Application No:	<u>3/21/18/081</u>
Parish	Minehead
Application Type	Full Planning Permission
Case Officer:	Sue Keal
Grid Ref	Easting: 297187 Northing: 146626
Applicant	Mrs MacLean
Proposal	Installation of sculpture pole with 2 downward pointing projecting lights
Location	The Esplanade, Minehead
Reason for referral to	The recommendation is contrary to the views of the
Committee	Town Council.

Application No 3/21/18/081 Installation of sculpture pole with 2 No. downward pointing projector lights The Esplanade, Minehead WEST SOMERSET COUNCIL

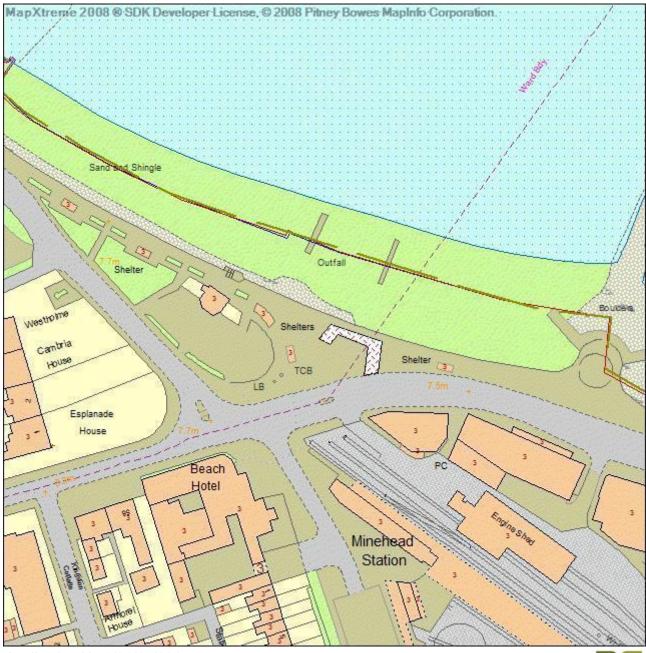
The lighting of the proposed sculpture may present a distraction to motorists.

The proposed location for the feature appears to be aligned to westbound traffic on the Esplanade. Westbound traffic is travelling around a left-hand bend with a defined uncontrolled pedestrian crossing point. Light distraction may result in vehicle/pedestrian conflict. The sketch below indicates sight lines of approaching traffic; the pedestrian uncontrolled crossing and the approximate location of the feature.

It is assumed that the projection is on to the ground. The projection of light should not impact on approaching motorists.

The lighting designer should ensure that the lighting design does not cause an unnecessary distraction to motorists.
